UNITED STATES PATENT AND TRADEMARK OFFICE

APPLICATION NO.	FILING DATE	FIRST NAMED INVENTOR	ATTORNEY DOCKET NO.	CONFIRMATION NO.
10/576,326	01/24/2007	Saadettin Sel	12007-0070	9415
22902 7590 10/15/2008 CLARK & BRODY 1090 VERMONT AVENUE, NW SUITE 250 WASHINGTON, DC 20005				
EXAMINER				
BOOTH, MICHAEL JOHN				
ART UNIT		PAPER NUMBER		
4158				
MAIL DATE		DELIVERY MODE		
10/15/2008		PAPER

Office Action Summary

DETAILED ACTION

FIG. 2

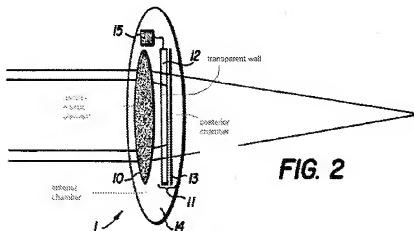
Large discloses a lens with an anterior and posterior chamber separated by a transparent wall, where the anterior chamber not facing the retina features at least one convex elastic element (column 3, lines 40-44) where alignment of the curve allows the focal width of this element is variable. (See FIG. 2). The word "chamber" is defined as a "natural or artificial enclosed space or cavity" by Merriam-Webster's online dictionary. Regarding claim 7, Large further discloses a lens with a supporting element for the recesses so that the inclination, as in when placing an object up, such as (23) against the recesses (22), the inclination angle is adjusted to meet that of the recesses depending on their angle. (See FIG. 4). Regarding claim 8, it is inherent that the supporting element is pre-stressed against rotation.

Large discloses a further optic means, such as a polarizer layer (13), that can be placed in the path of rays before or behind the lens device. (See FIG. 2).
